Addendum No. 1

Reference: Elevator Modernization-Provo Regional Center
Division of Facilities Construction and Management
DFCM Project No. 15038310

Subject: **Addendum No. 1**

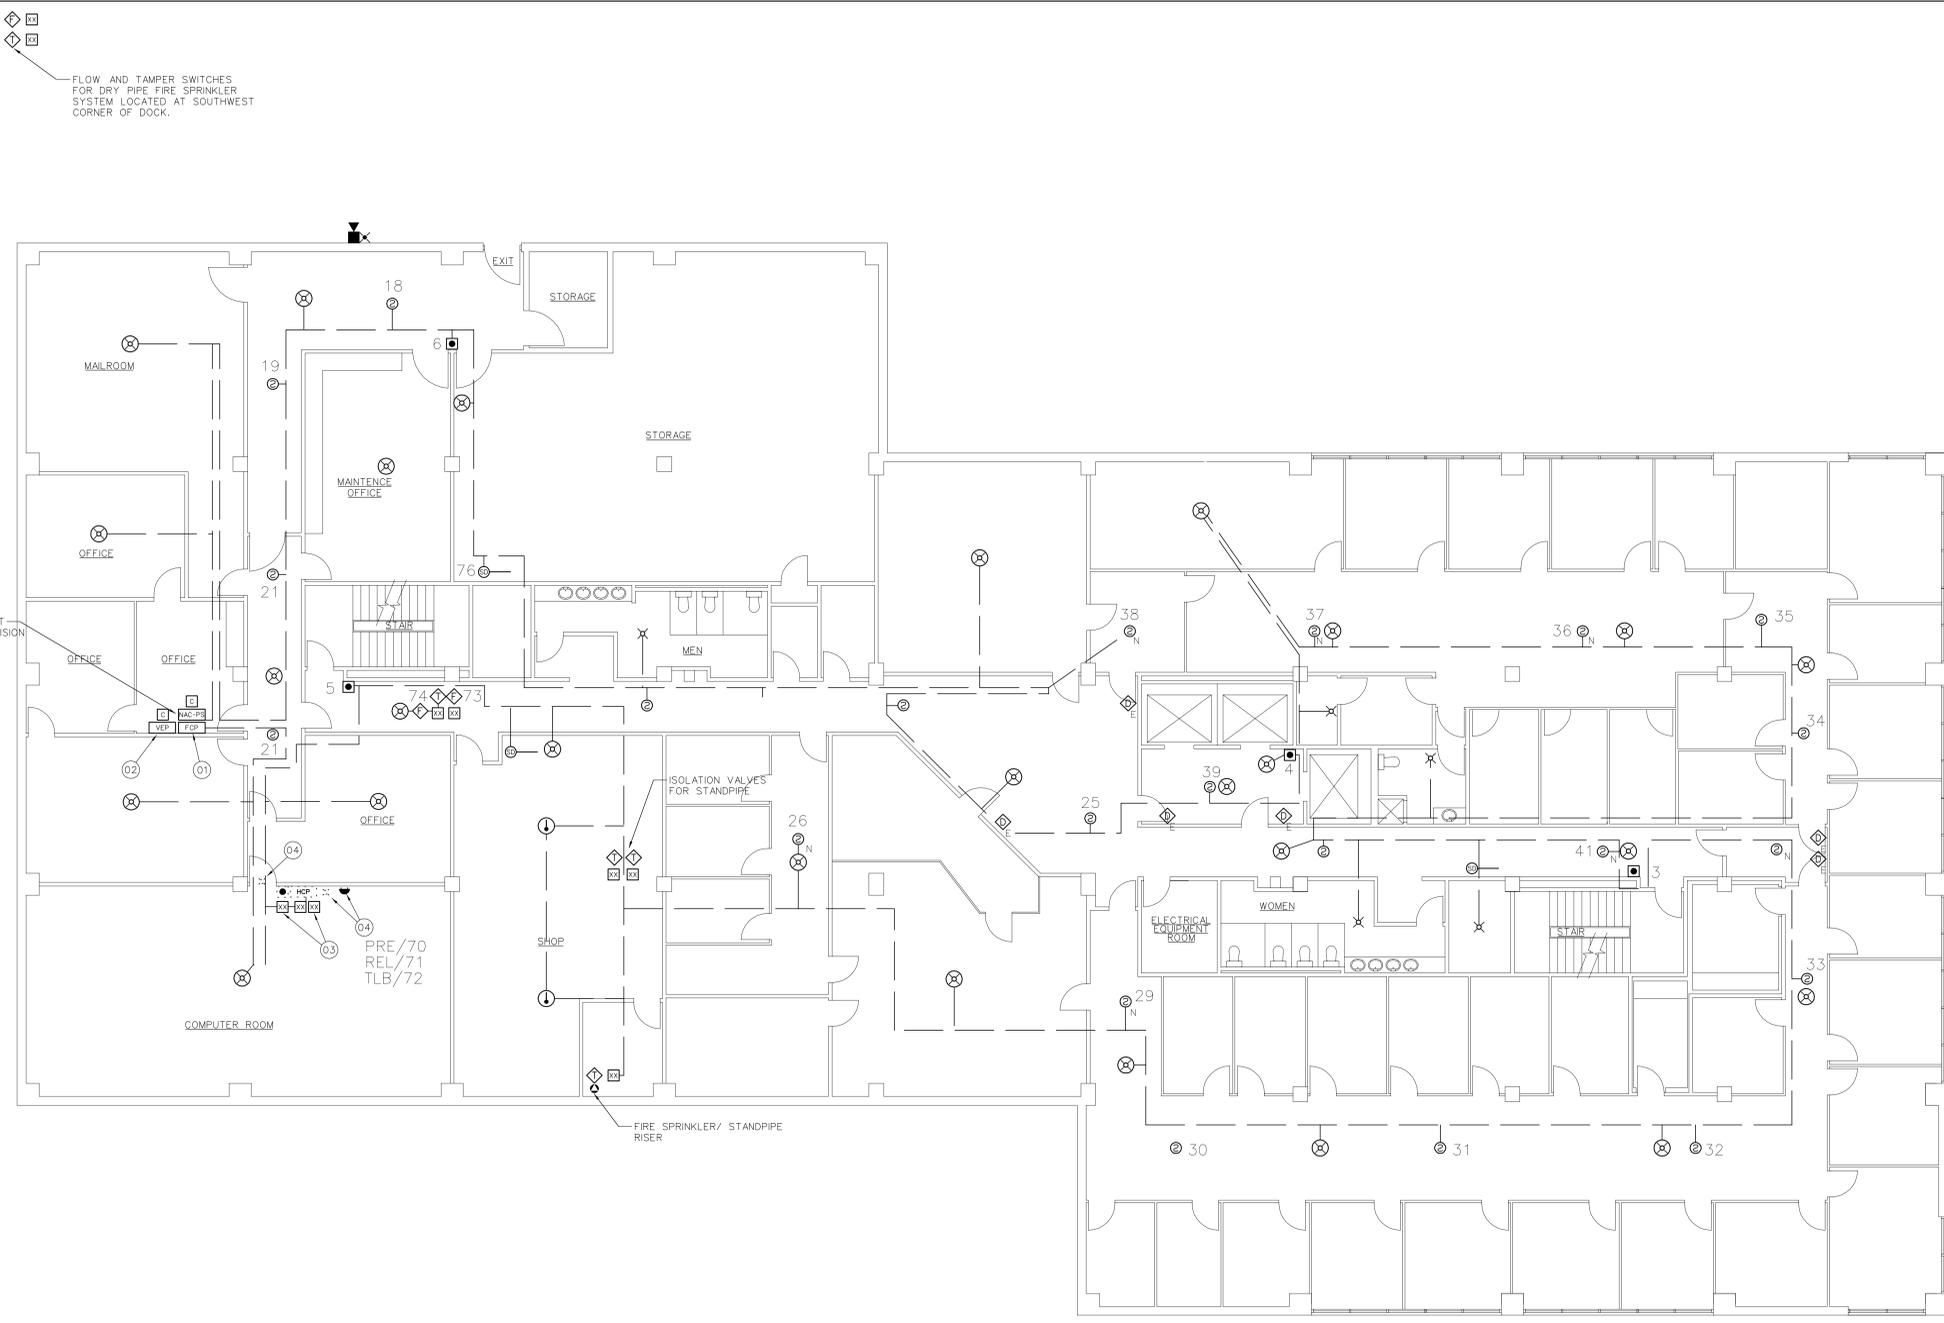
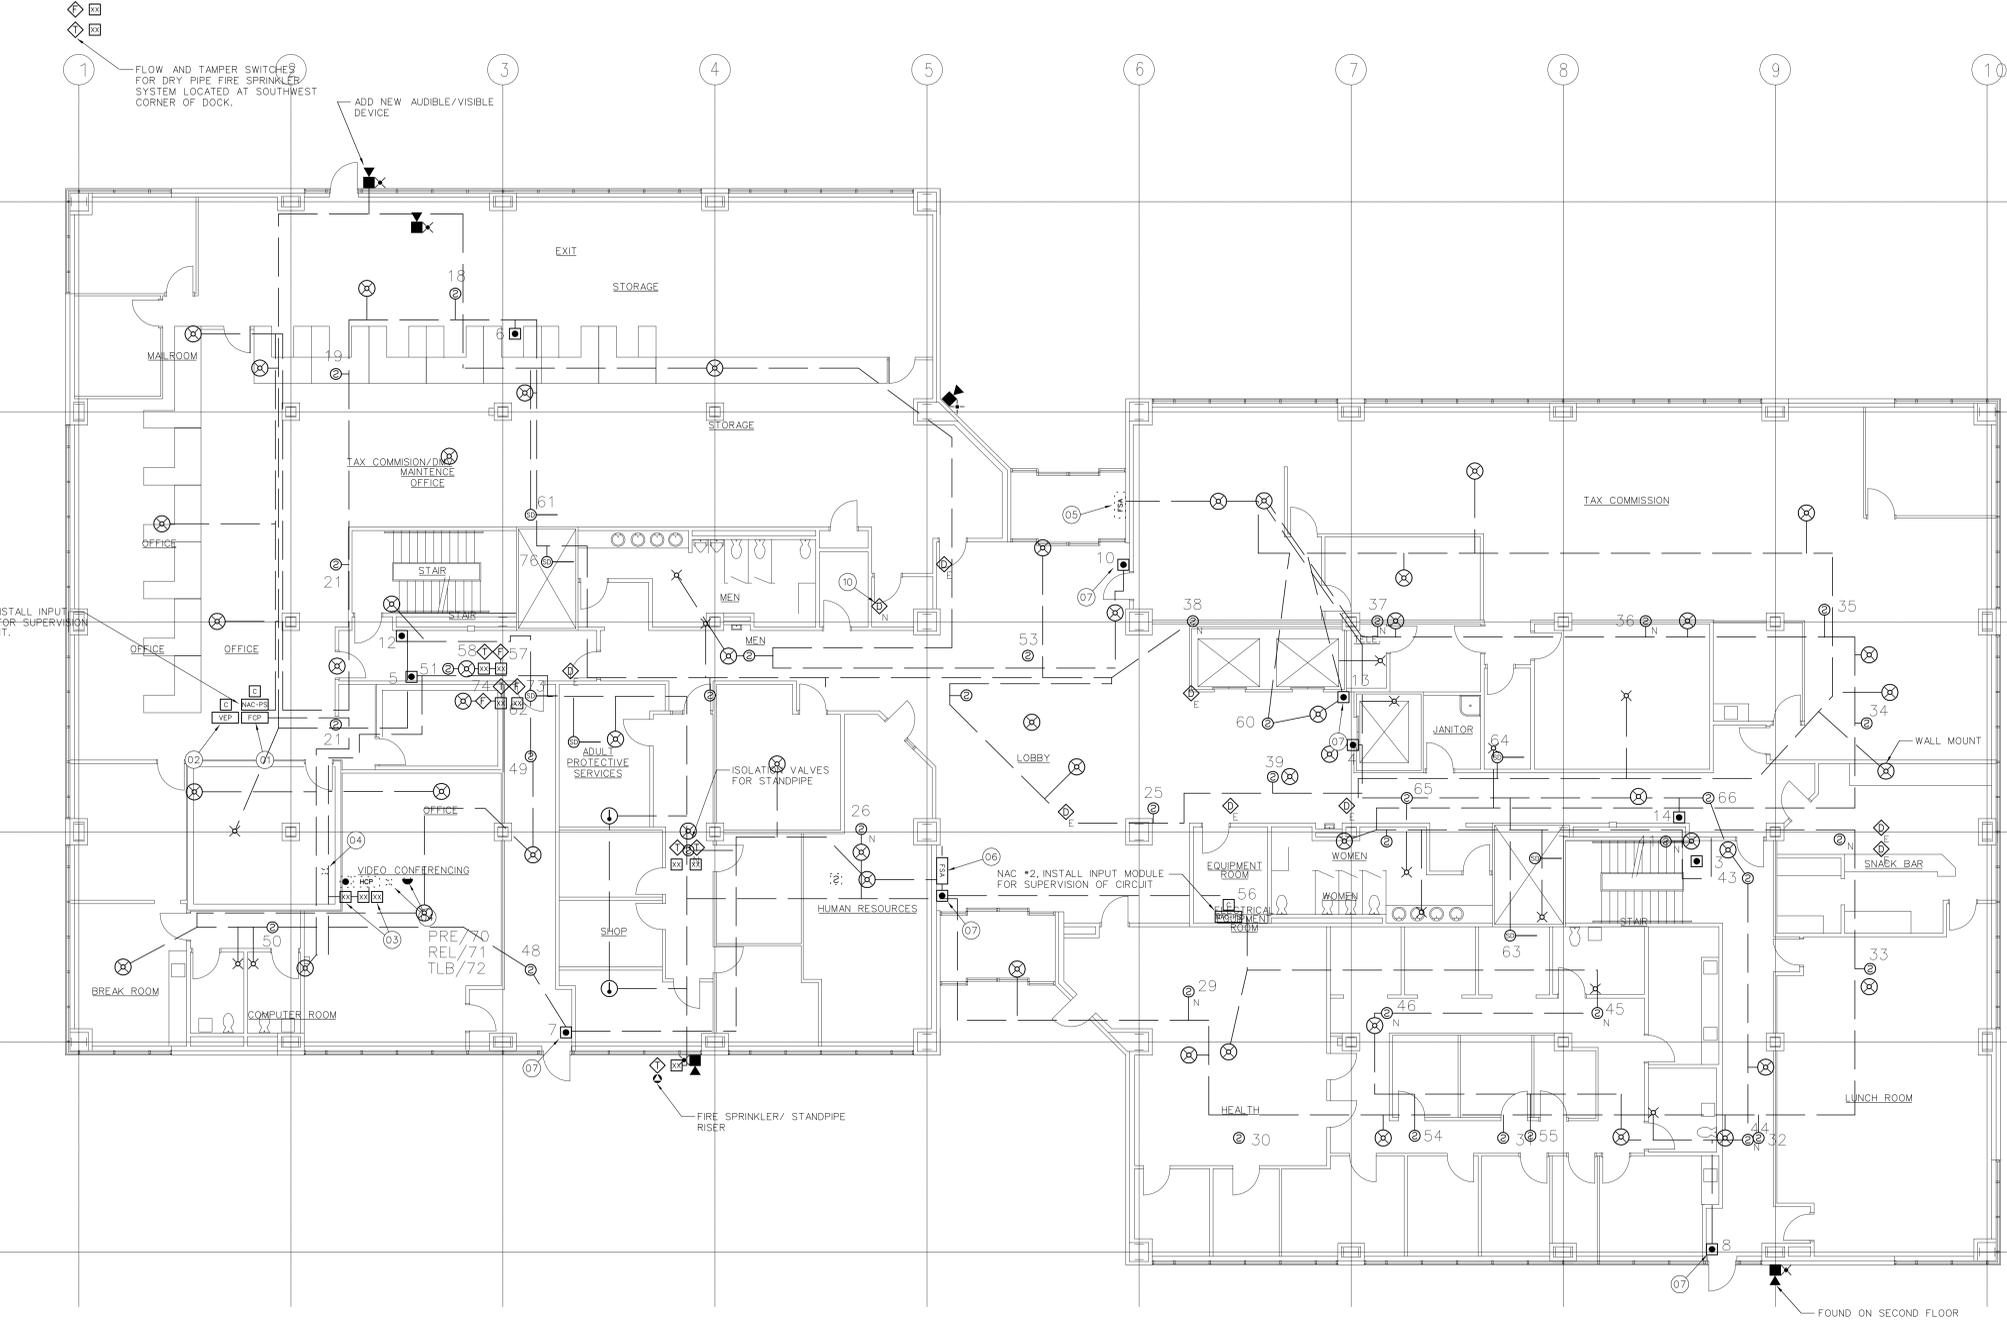
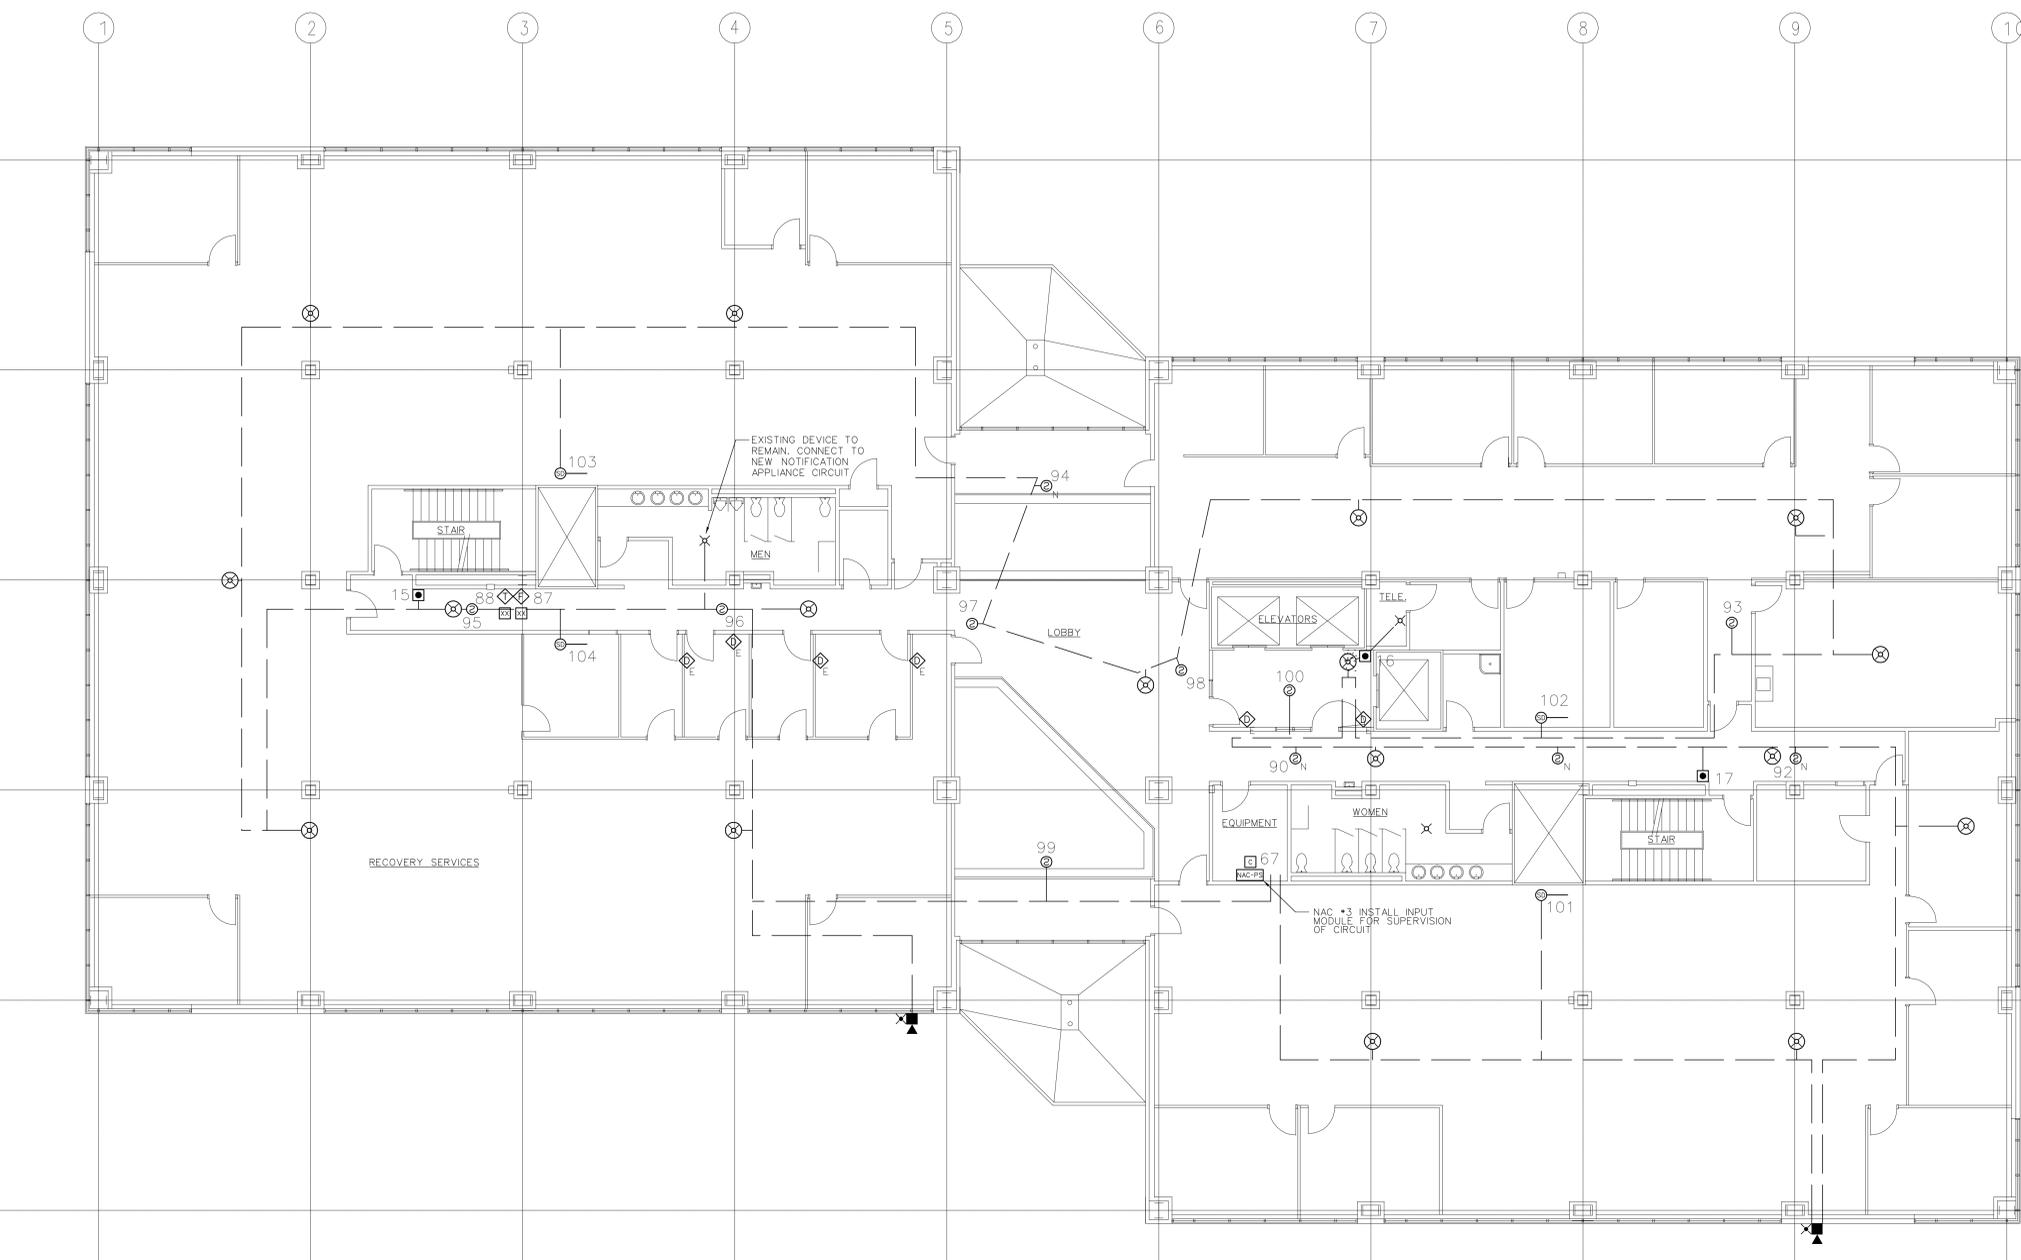
8. Is a building layout drawing available for bidders to review and plan accordingly?

Yes, attached to the addendum are the building's Fire Alarm System drawings per floor and also you can visit the building's haz-mat survey pages 57 through 63 entitled Floor Plans.
